Rezoning Transportation Analysis

Petition Number: 2019-152

Date	Description
11-21-19	First Review
12-23-19	Second Review
01-16-20	Third Review

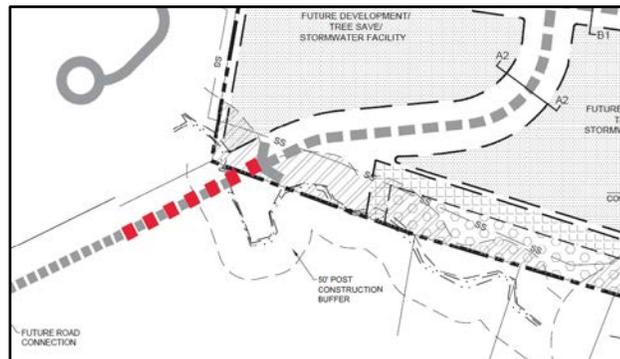
- ~~1. **Curblines** The proposed zoning district has a setback measured from back of the existing or proposed future curblines.~~
 - ~~a. **University City Boulevard:** Location of curb and gutter if it needs to be installed 13.5' from edge of travel lane~~

~~The site plan should show the curb and gutter labeled and dimensioned from the centerline for each road.~~
